CITY OF OXNARD
Environmental Impact Report

SCH #2000051046

1.0 INTRODUCTION

FIGURE 2-7

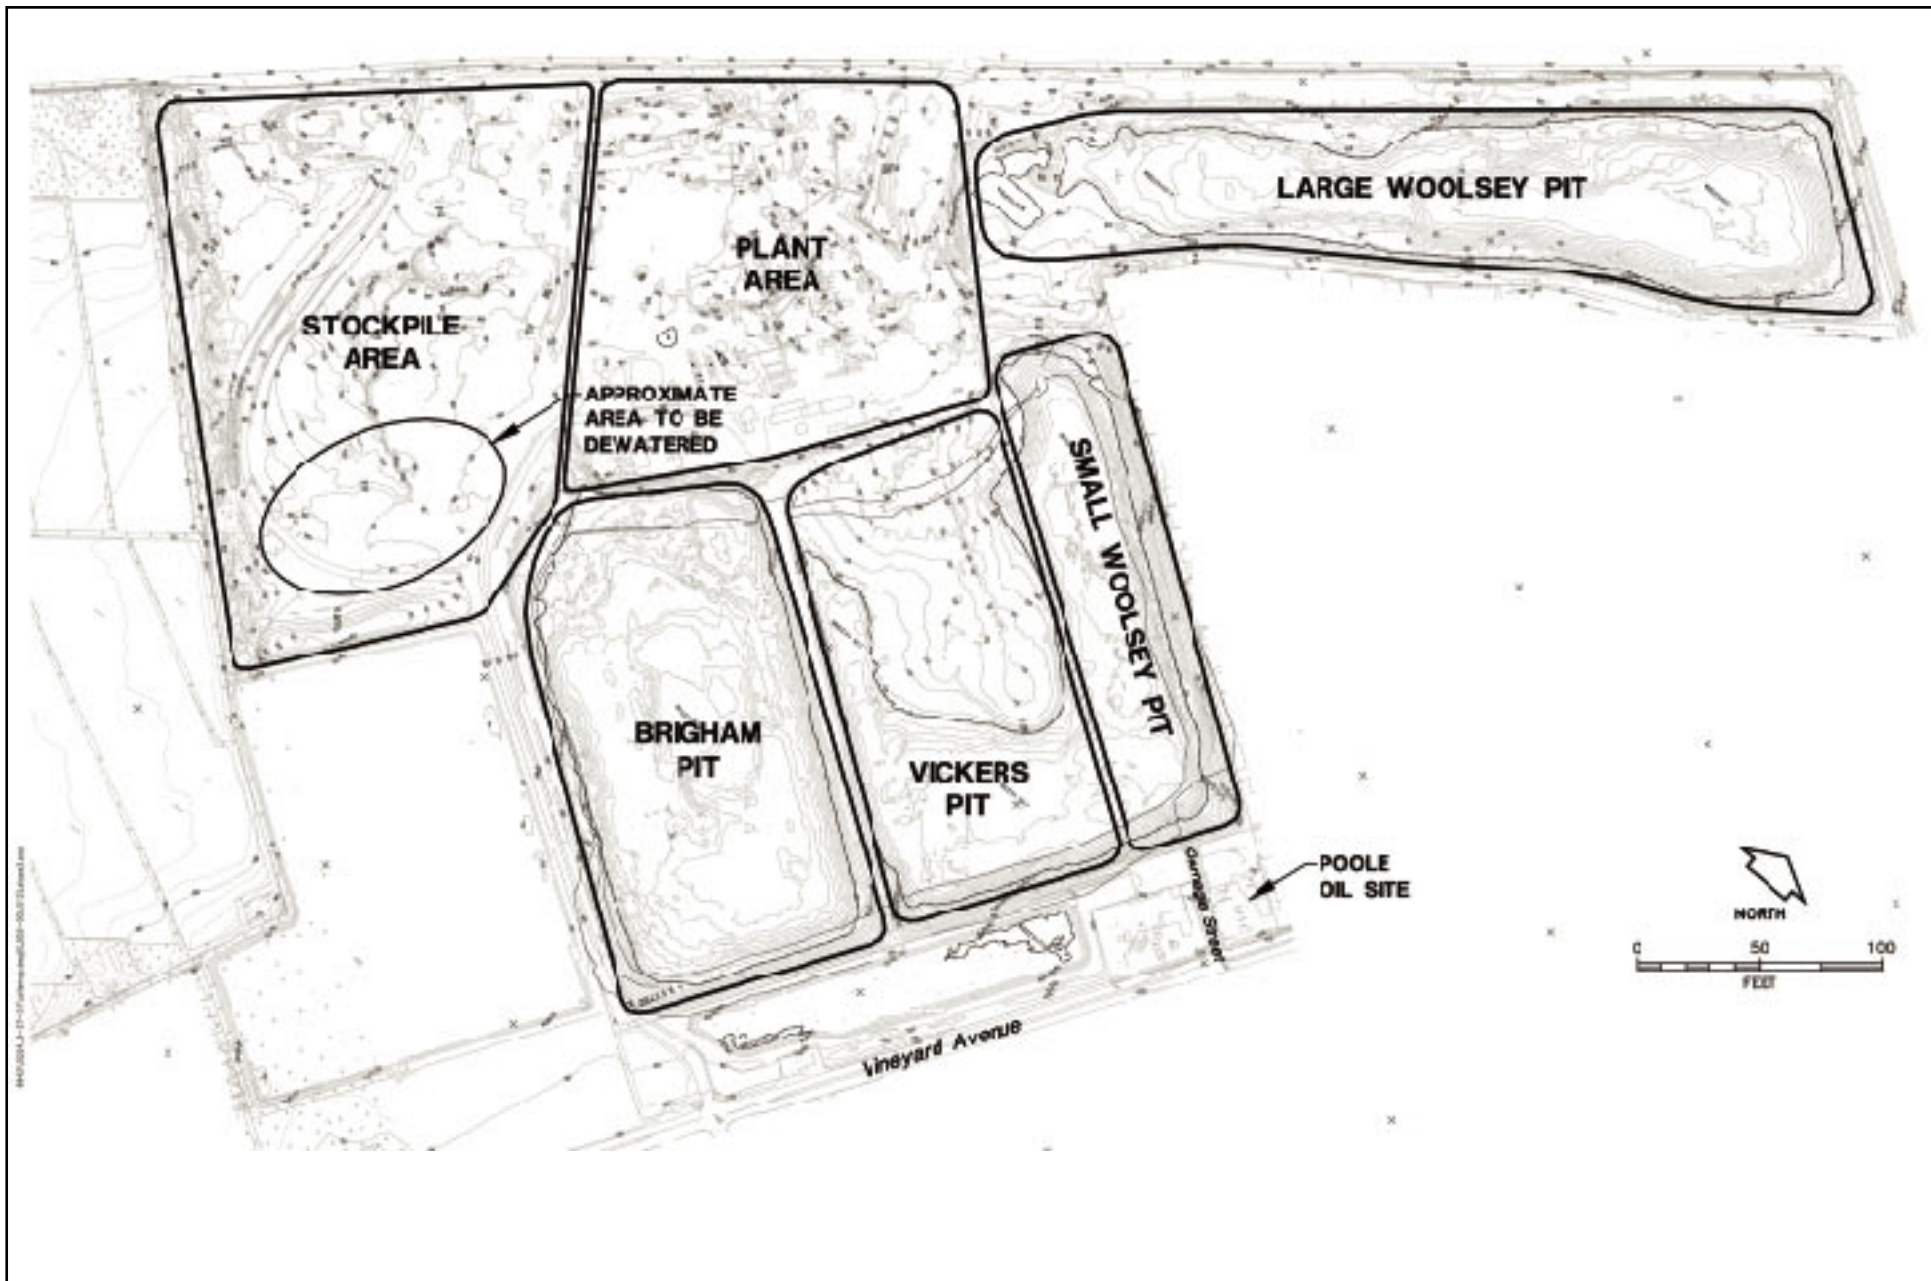
Since the preparation of the DEIR, the area requiring dewatering has been refined and the proposed dewatering operation has been further clarified by Fugro (see attached **Figures 2-7** and **2-8** for area and previous extent of proposed excavation). The area requiring deep excavation (and extensive dewatering to approximately 20 feet above MSL) has been clarified and greatly reduced from approximately 37 acres to approximately 5.5 acres (approximately a 400 feet by 600 feet area) as represented by Area D on attached **Figure 2-9** (Fugro, 2002). The reduction in area has reduced the required dewatering period presented in the DEIR (page 4.5-70) from three to four months to approximately 55 days.

FIGURE 2-11

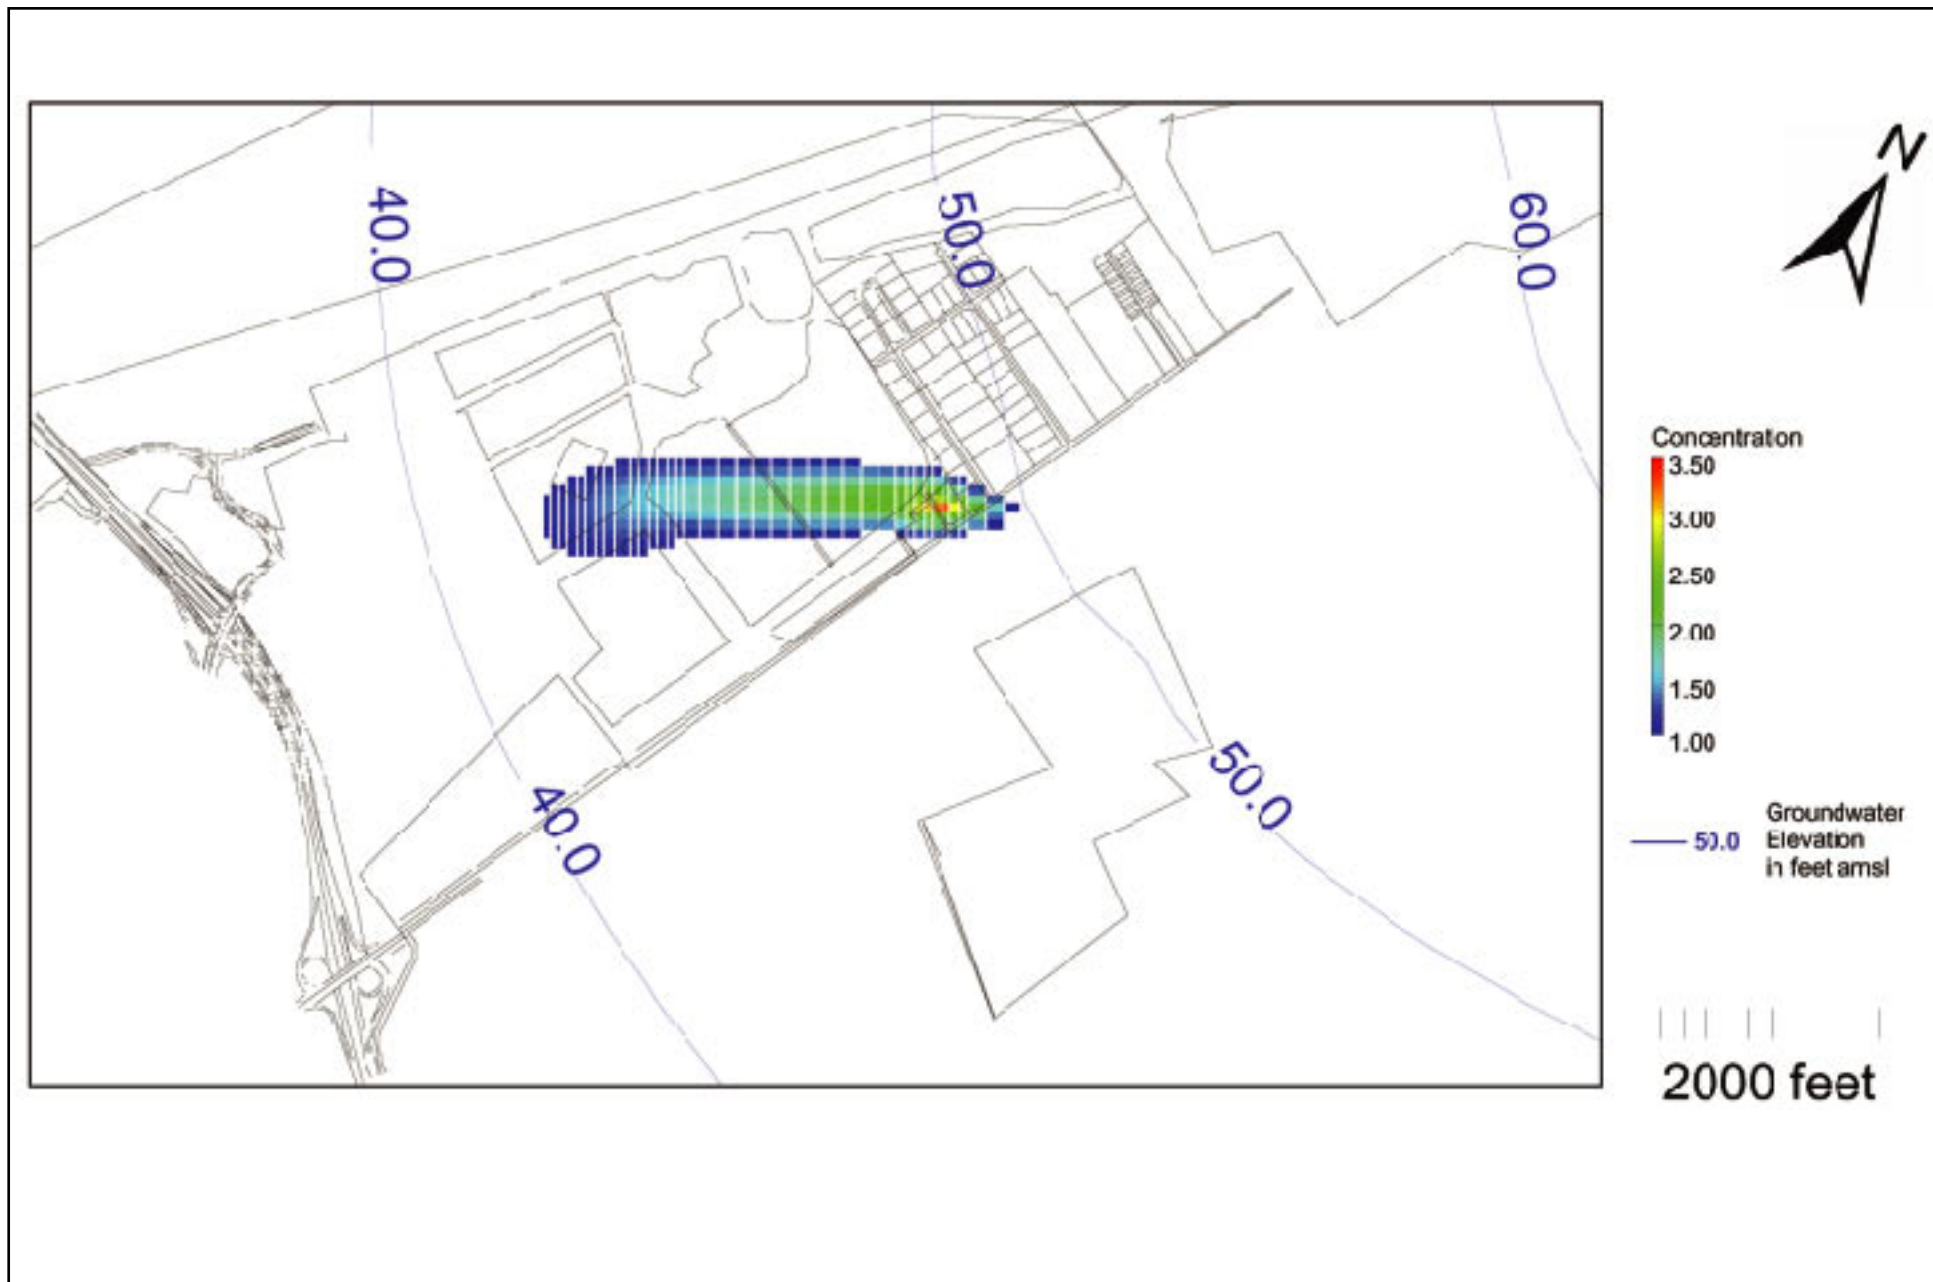
The baseline one-year flow simulation indicates that the contamination from the Poole Oil Company Site would migrate approximately 3,400 feet downgradient (attached **Figure 2-10**) in one year, under ambient conditions. A modeling run simulating 60 days of dewatering operations followed by 305 days of non-pumping conditions indicates that the travel distance over one year would be similar, extending approximately 3,900 feet from the Poole Oil Company Site (attached **Figure 2-11**).

FIGURE 2-14

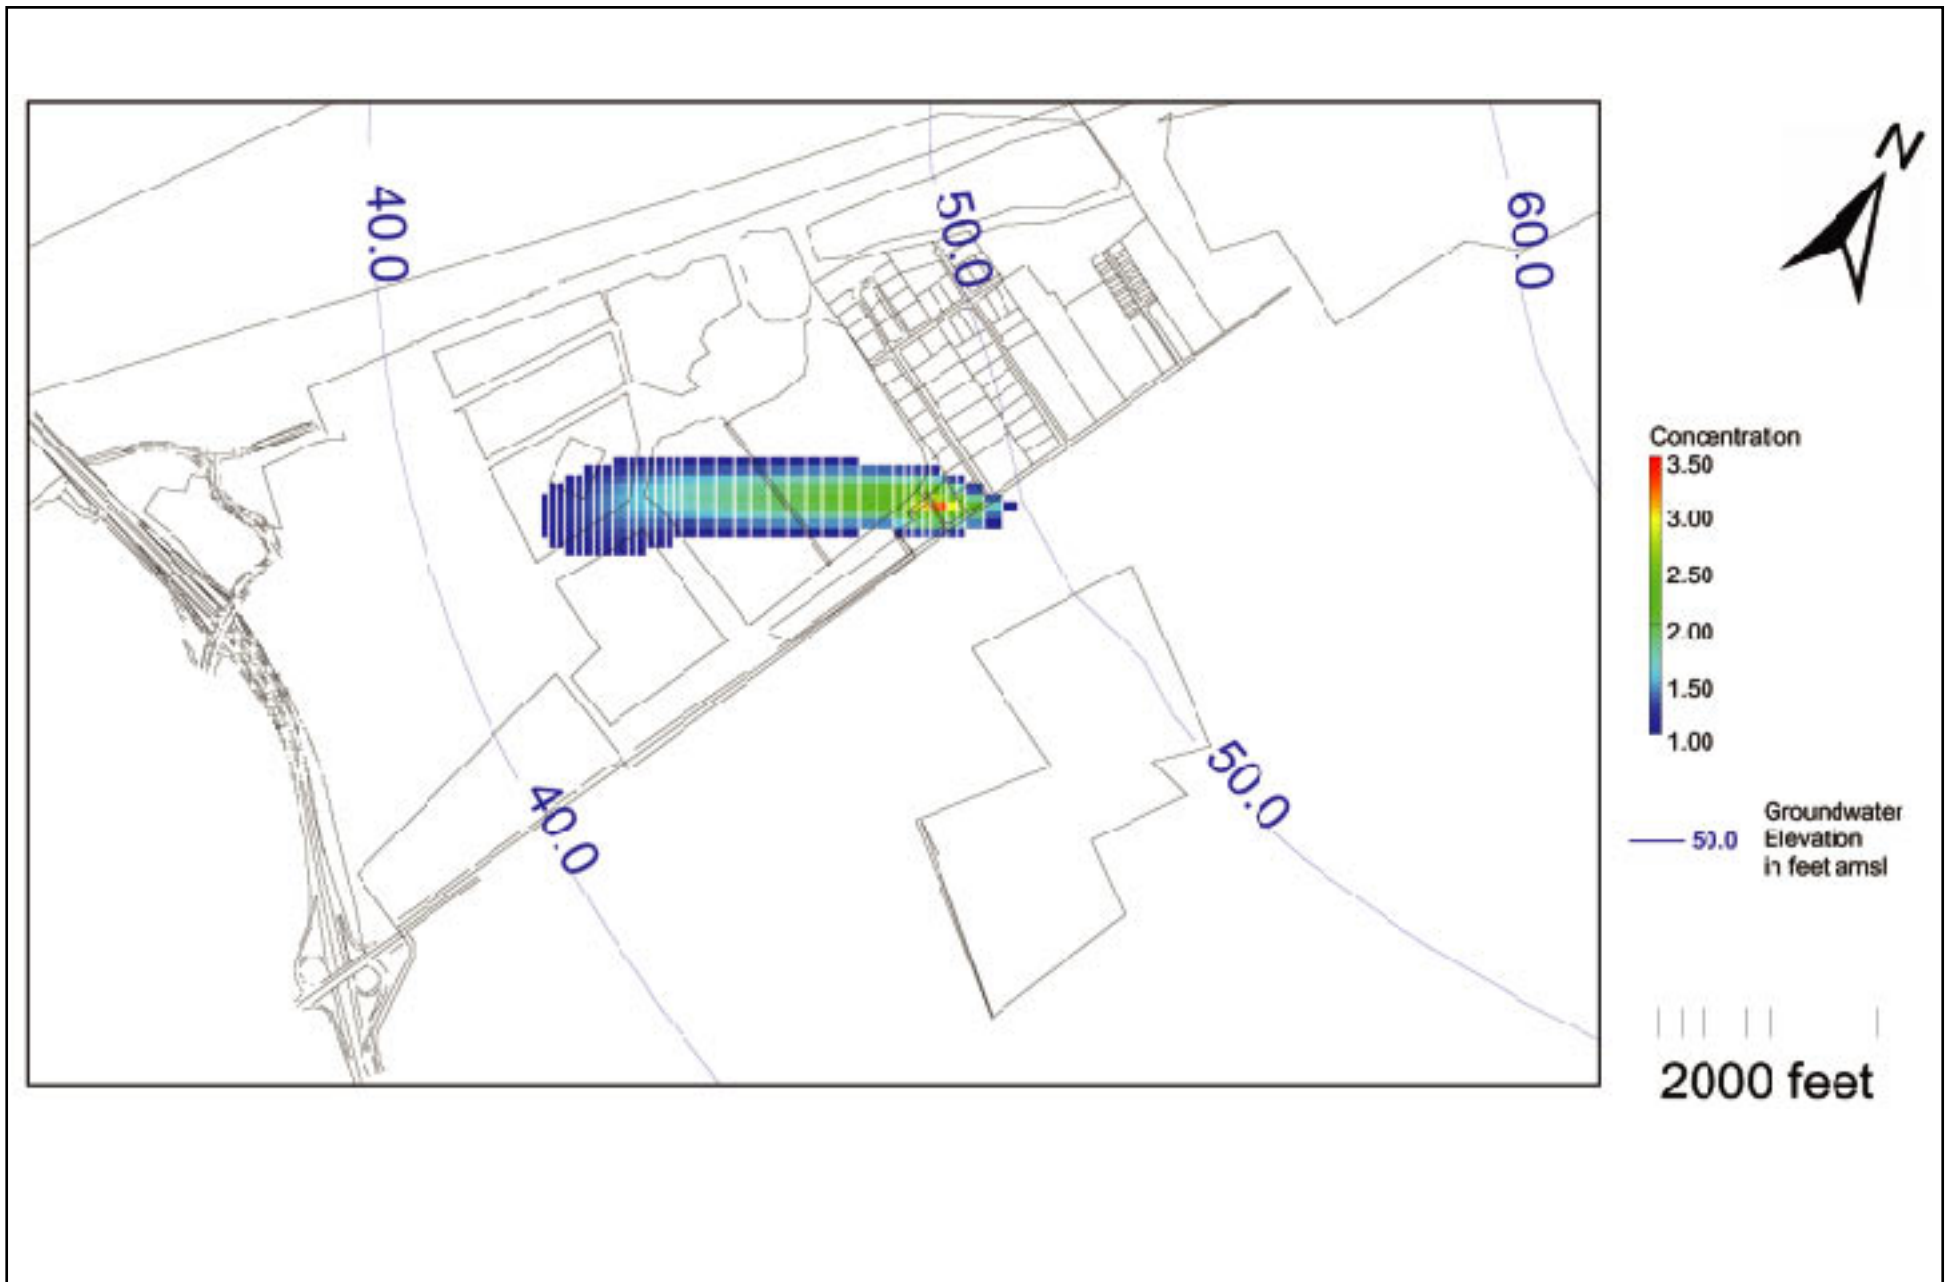
This modeling conservatively does not account for any dilution effects of the pits and also does not consider that local groundwater gradients vary dramatically from season to season and from year to year in the Forebay Basin over a standard water year (see Fugro (2001) Figure 3: Water level hydrograph for State Well No. 2N/22W-22H1). The baseline scenario indicates that the contamination from the Poole Oil Company Site would migrate approximately 3,400 feet downgradient (attached **Figure 2-14**) in one year, under ambient conditions.

FIGURE 2-17

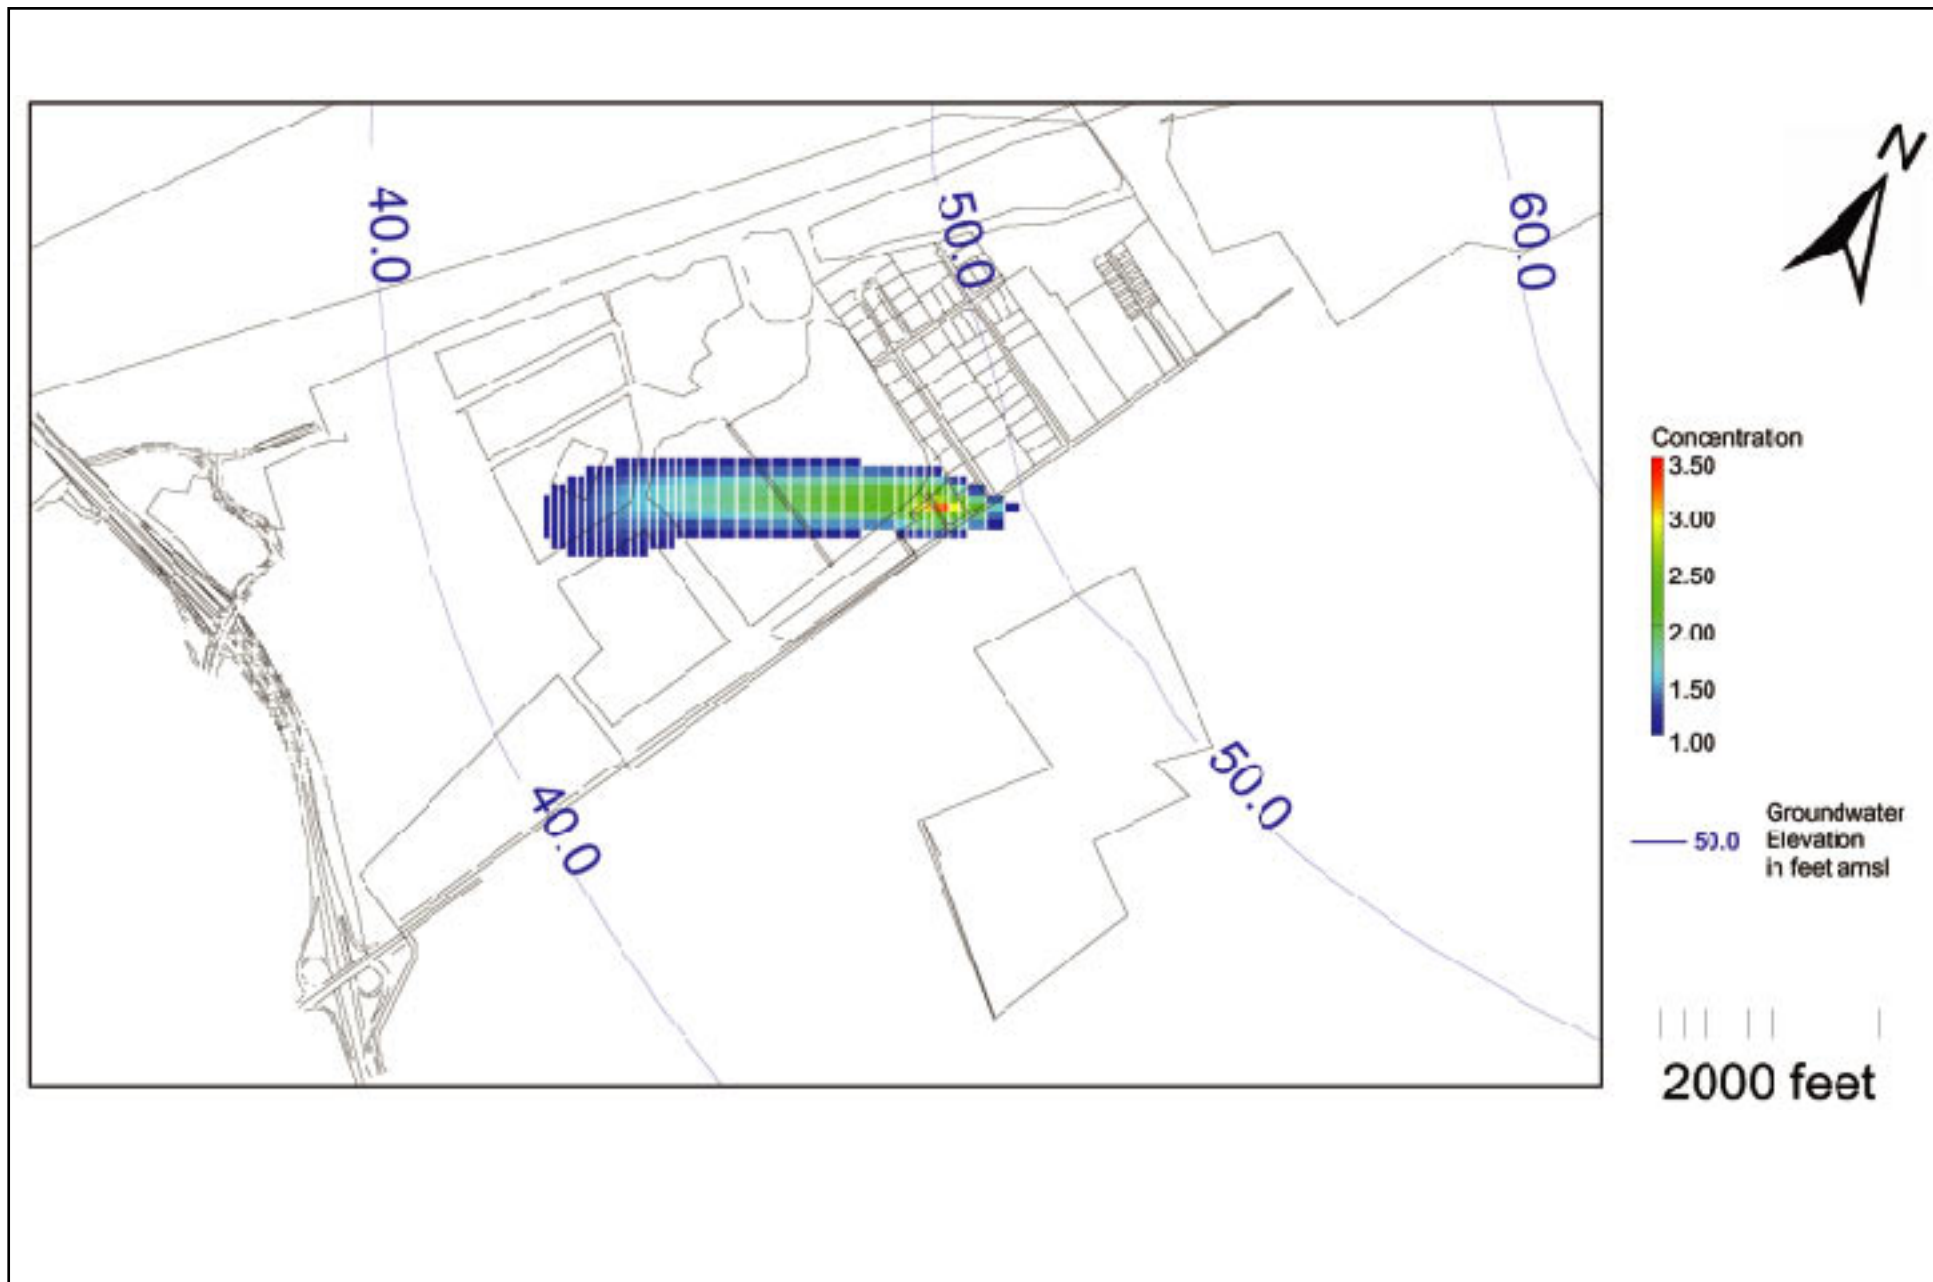
The result of the baseline scenario indicates that relative capture of the groundwater contamination is possible (see attached **Figure 2-16**). The scenario that includes one-year of recharge to the Pits indicates that even though approximately 6,000 acre-feet are recharged to the northwest of the Poole Oil Site, the extent of contamination is almost identical to the baseline condition (see attached **Figure 2-17**).
